## Addendum #2

Directorate of Facilities Engineering

14 September 2016

**Sanford Armory Renovation, 88 William Oscar Emery Drive, Sanford, Maine, Project Number 23SR15-424-D, BGS Project Number 2518, Bid Number 17-005.**

SHEET ID: Q-107
SHEET: 99 of 181

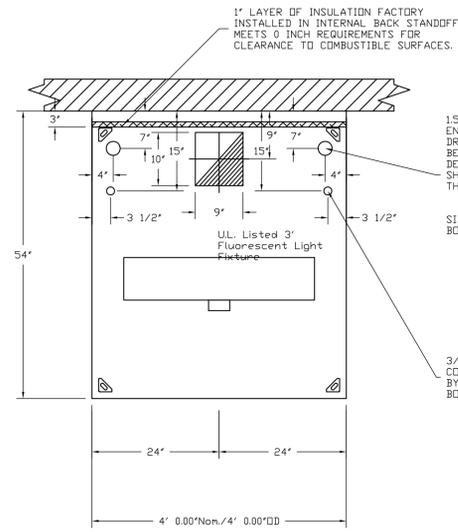
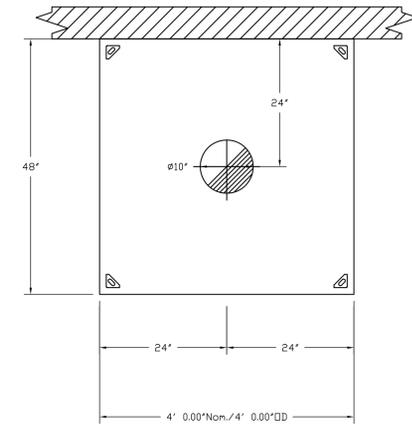
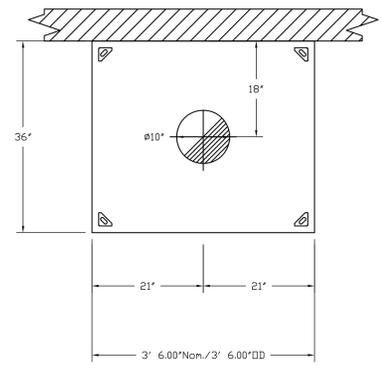
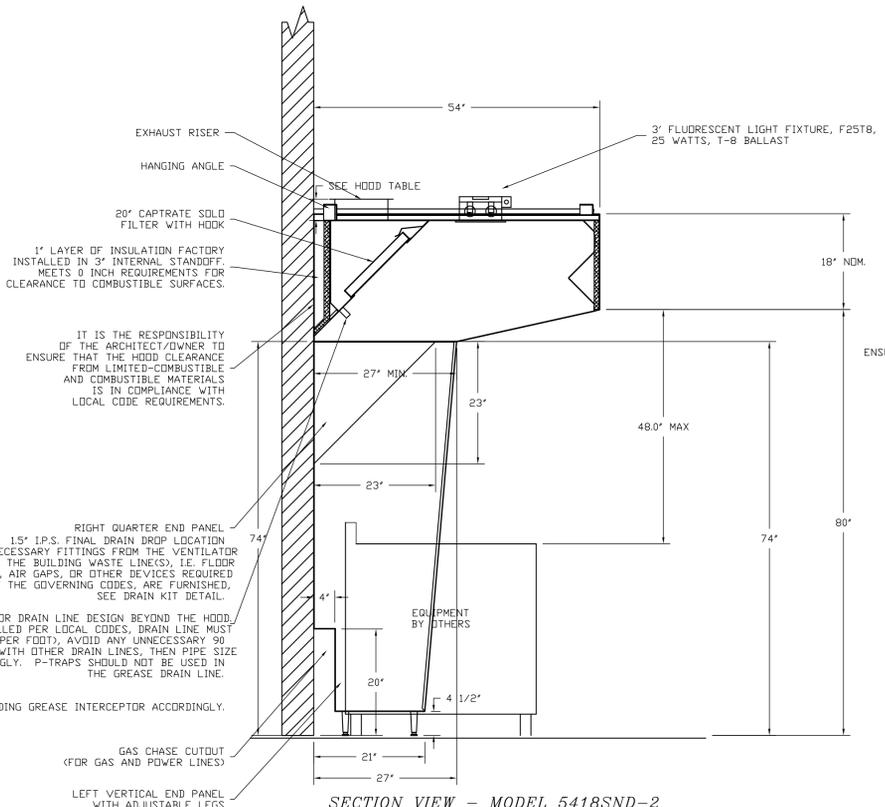
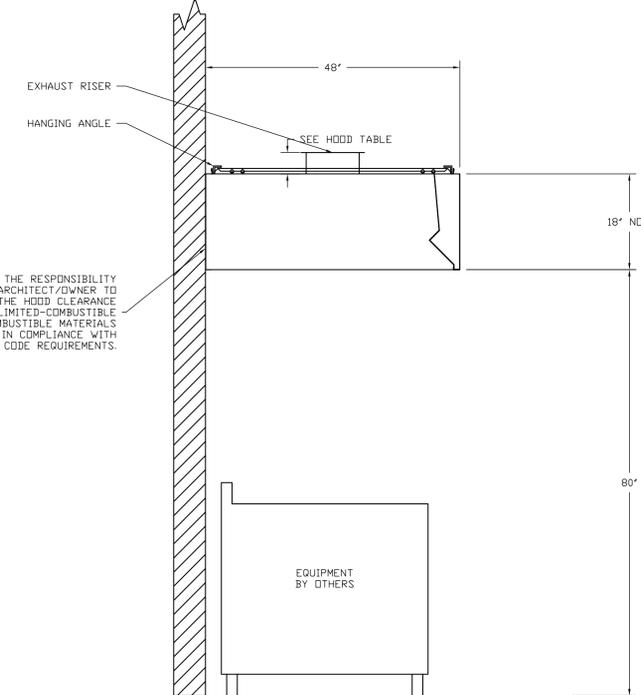
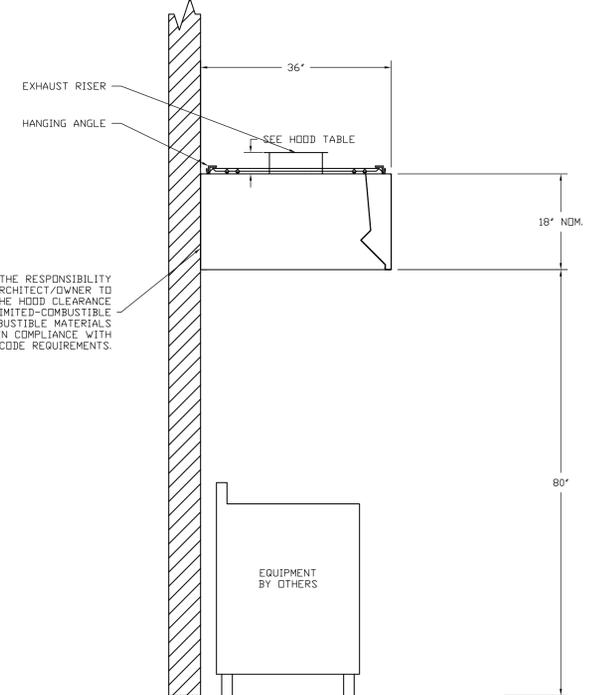
- b. Paragraph 3.5, **Replace** Item #21 with the following:

Item #: 21

Description: Exhaust Hood System

Manufacturer: Captive-Aire

Model #: 5418 SND-2

Unit to be size and shape as shown on plans and in details. Model 5418 SND-2, 4'-0" long sloped exhaust only, wall canopy hood for low ceiling applications with built-in 3" back standoff, self-cleaning.

c. Paragraph 3.5, **Replace** Item #31 with the following:

Item #: 31

Description: Condensate Hood

d. Paragraph 3.5, **Replace** Item #38 with the following:

Item #: 38

Description: Condensate Hood

SHEET ID:  
Q-108  
SHEET: 100 of 181

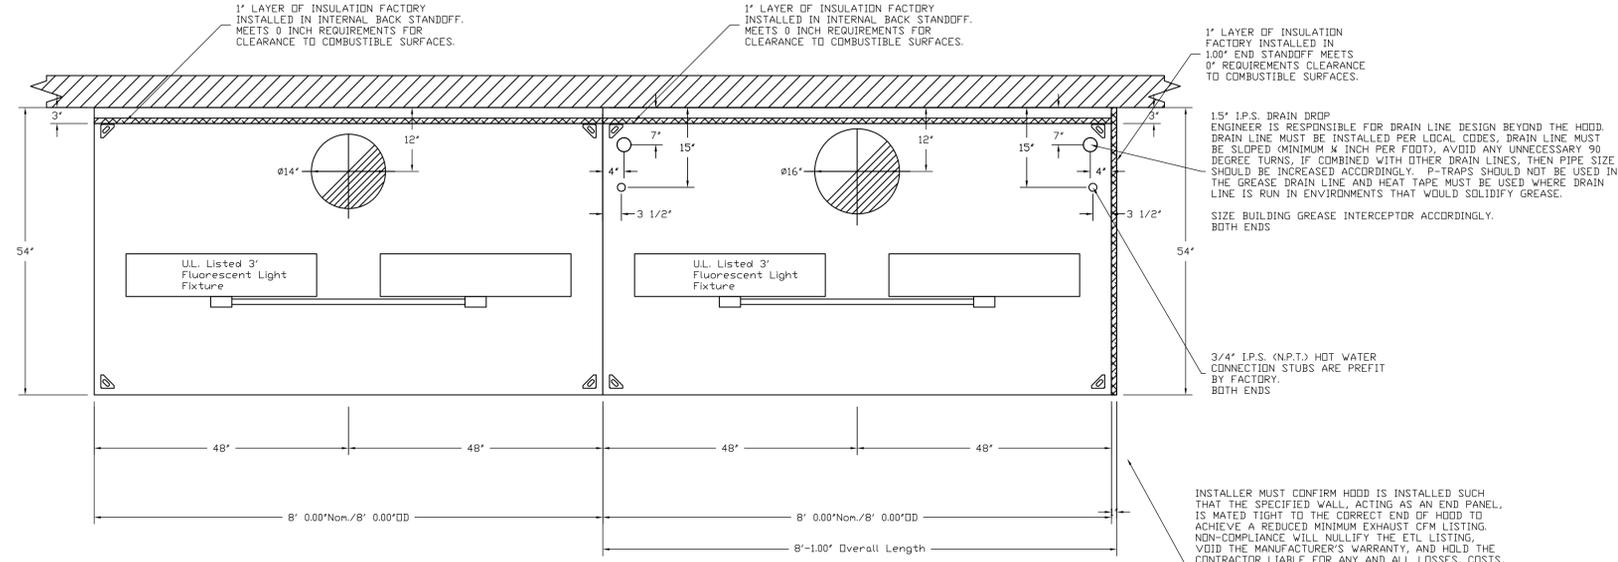
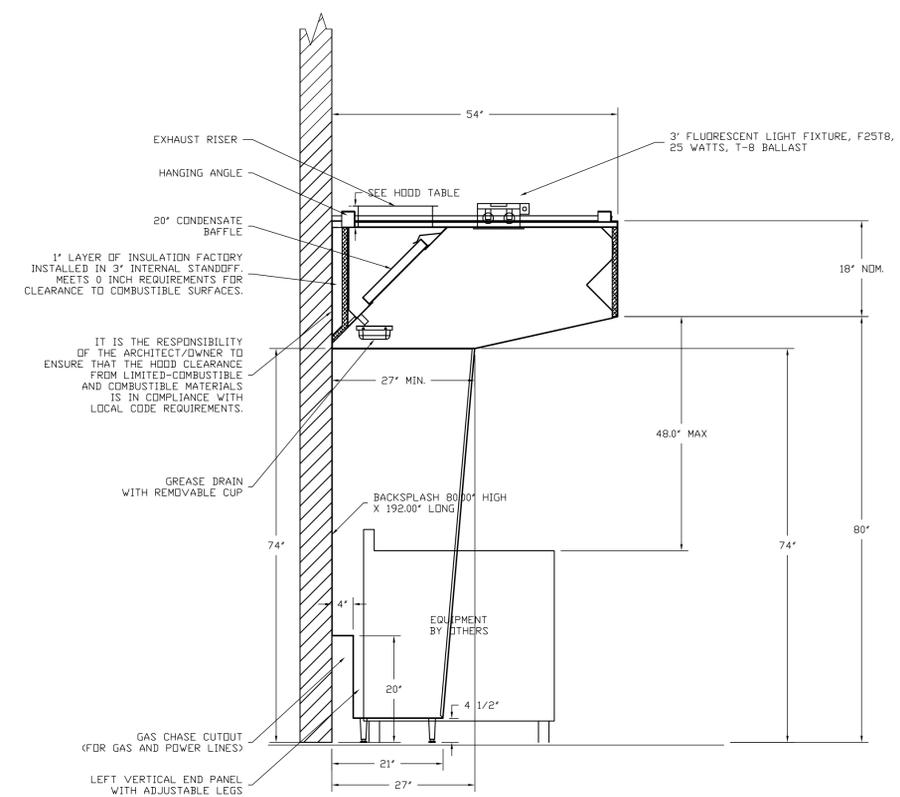
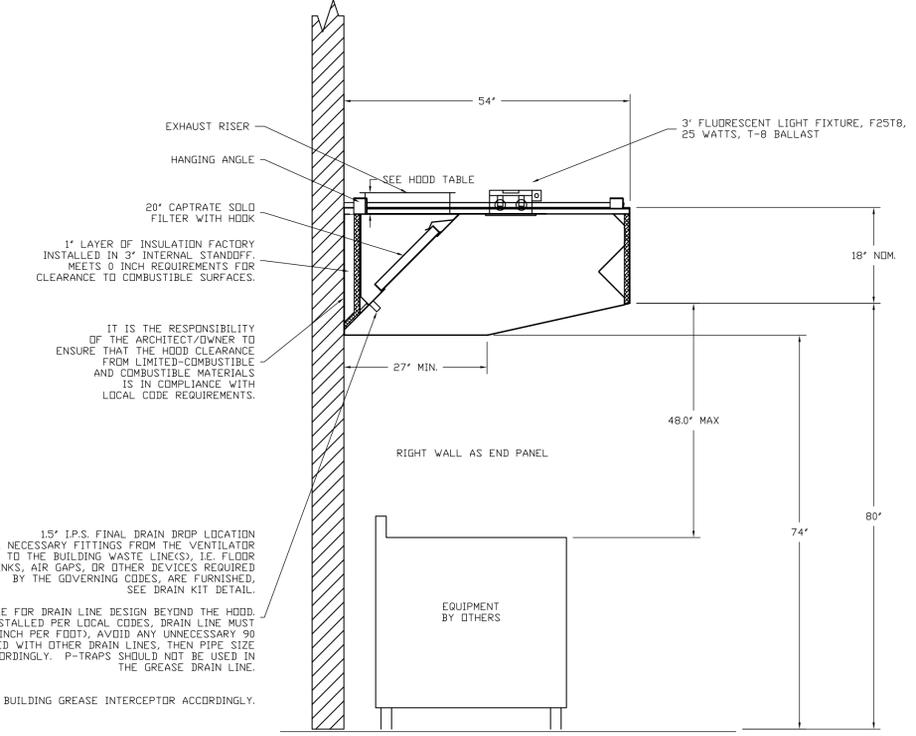
e. Paragraph 3.5, **Replace** Item #50 with the following:

Item #: 50  
Description: Exhaust Hood  
Manufacturer: Captive-Aire  
Model #: 5418 SND-2  
Log Classification: A  
National Stock Number: NNSN  
SIS #: T037  
Quantity: 1

Unit to be size and shape as shown on plans and in details. Model 5418 SND-2, 8'-0" long sloped exhaust only, wall canopy hood for low ceiling applications with built-in 3" back standoff, self-cleaning.

f. Paragraph 3.5, **Replace** Item #51 with the following:

Item #: 51

Description: Condensate Exhaust Hood

Unit to be size and shape as shown on plans and in details. Model 5418 SND-2, 8'-0" long sloped exhaust only, wall canopy hood for low ceiling applications with built-in 3" back standoff, self-cleaning.

SHEET ID:  
 SF901  
 SHEET: 174 OF 181

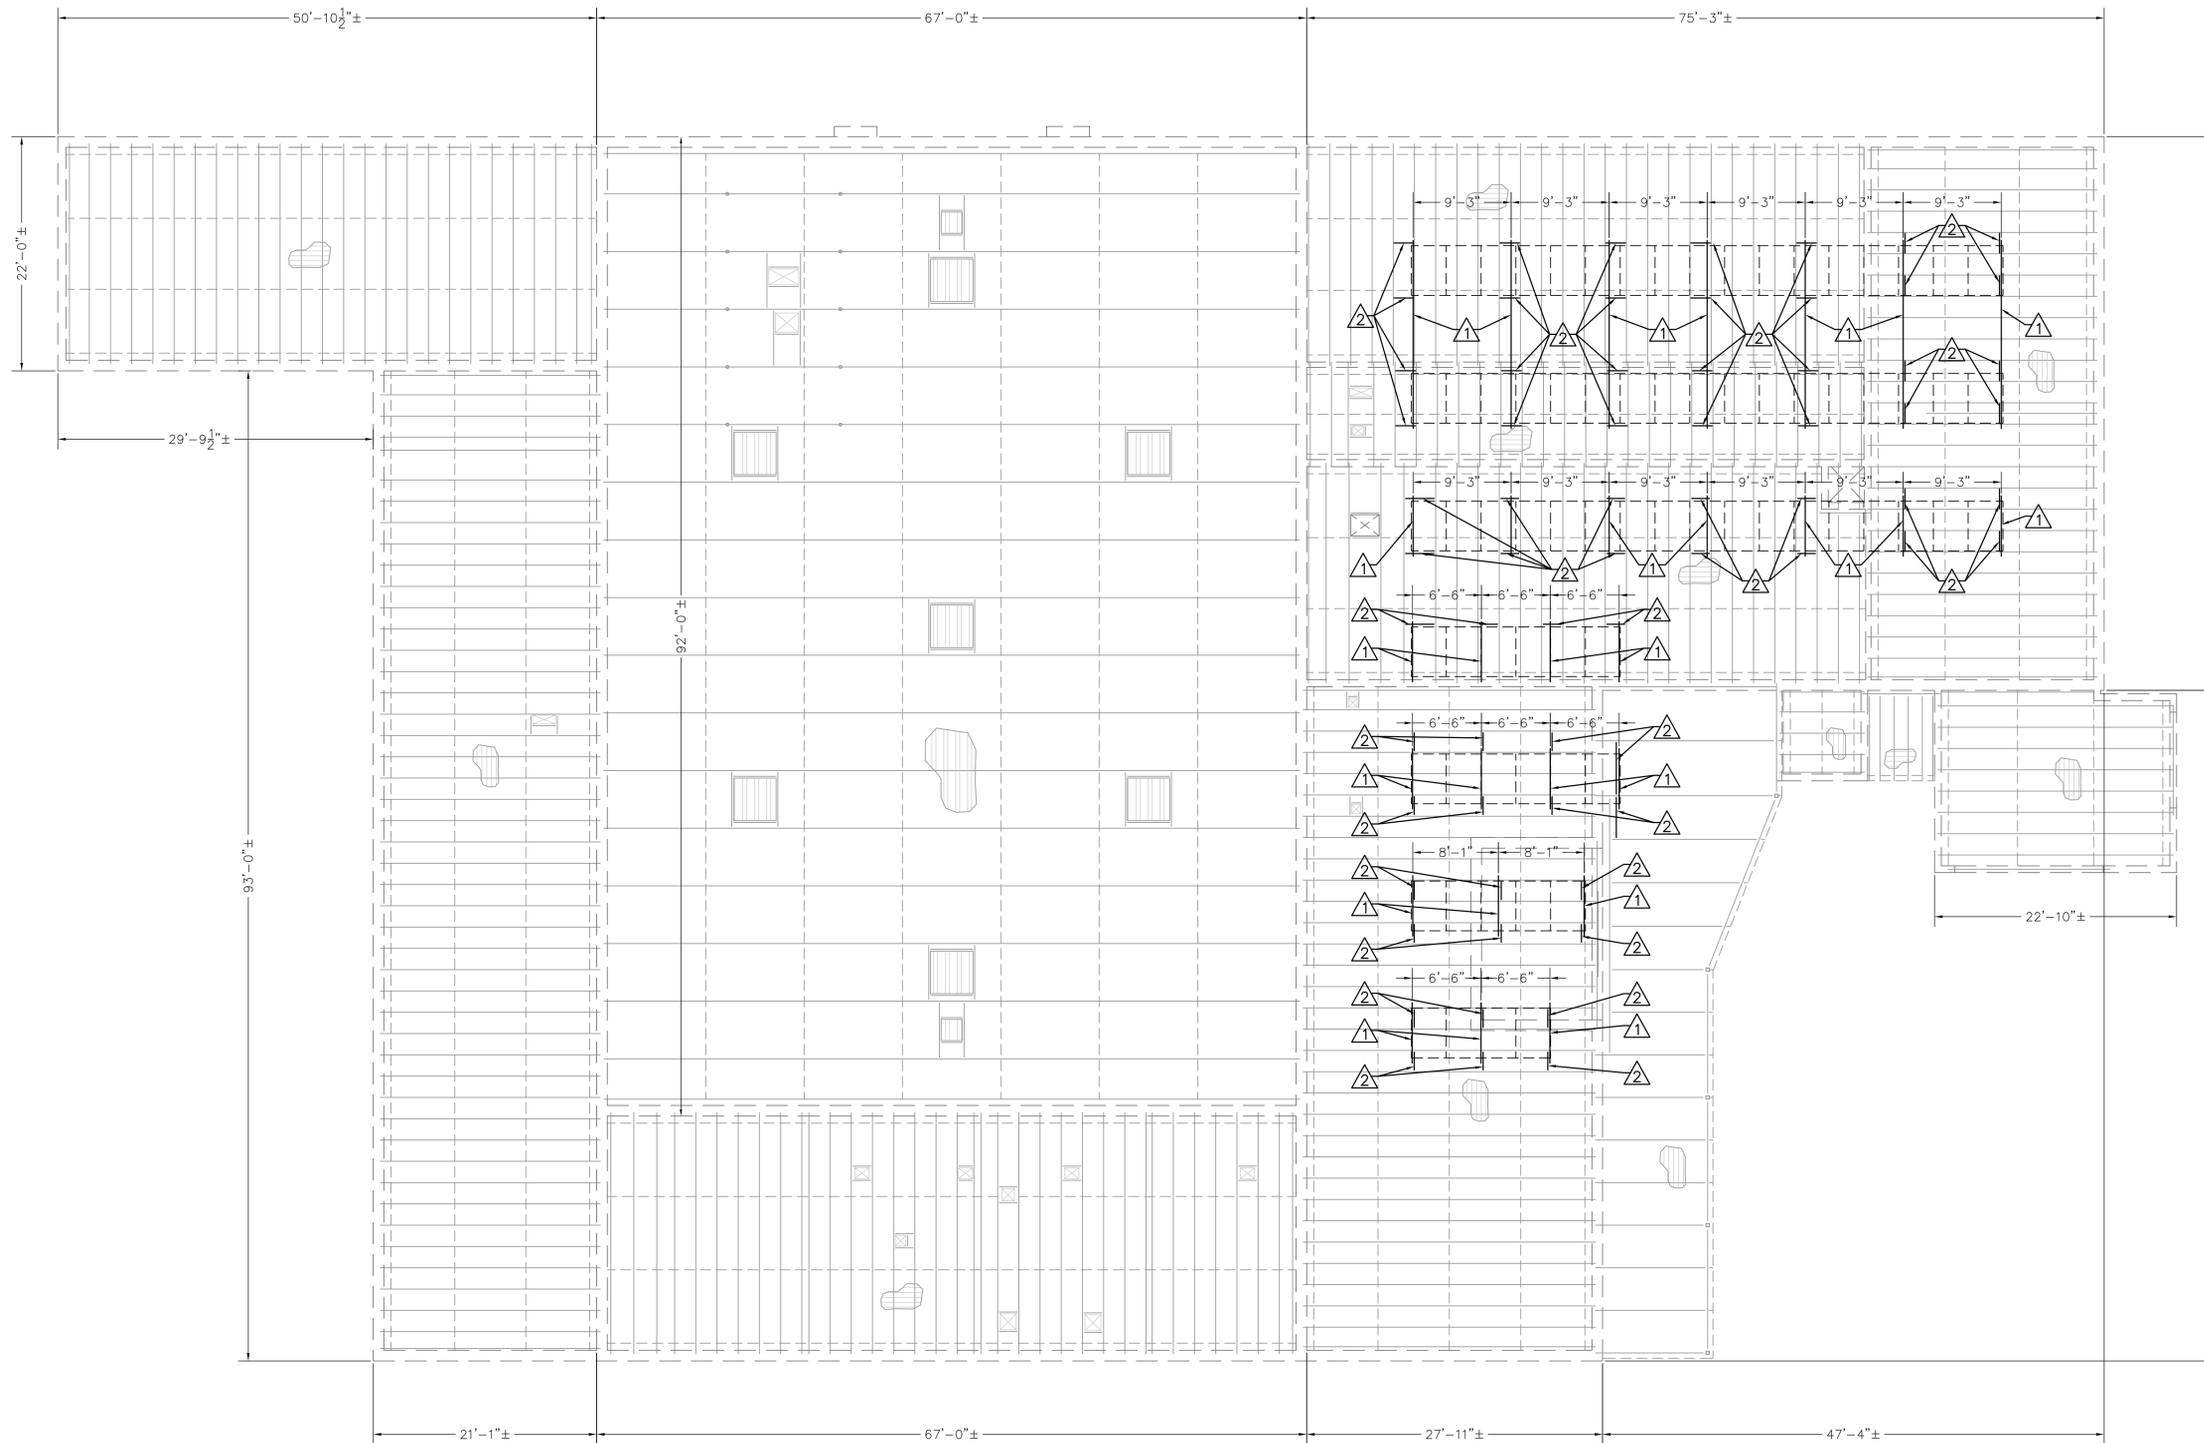
- a. Paragraph 1.4.C., **Add** subparagraph 5.:
  5. Submit shop drawings and design calculations prepared by a Licensed Professional Engineer in the State of Maine.
- b. Paragraph 2.10, **Revise** as follows:

2.10 MOUNTING STRUCTURES

- A. Basis-of-Design Product: Sunlink Precision RMS
- B. Roof Mount: Ballasted system shall be provided that results in no net uplift wind forces on structure assembly.
- C. Photovoltaic panels shall mounted at 30 degrees from structure facing south.
- D. Design the PV structural supports to resist wind forces calculated in accordance with ASCE 7-10 for a wind velocity of 118 MPH, exposure B and risk category II.

- E. Design frames for the seismic forces calculated in accordance with ASCE 7-10 for the seismic criteria indicated.
- F. Design load combinations shall be in accordance with chapter 2 of ASCE 7-10.
- G. No penetrations shall be made thru roof structure or roofing system to attach frames.
- H. Maximum transverse spacing of frames shall not be greater than 9'3" on center.
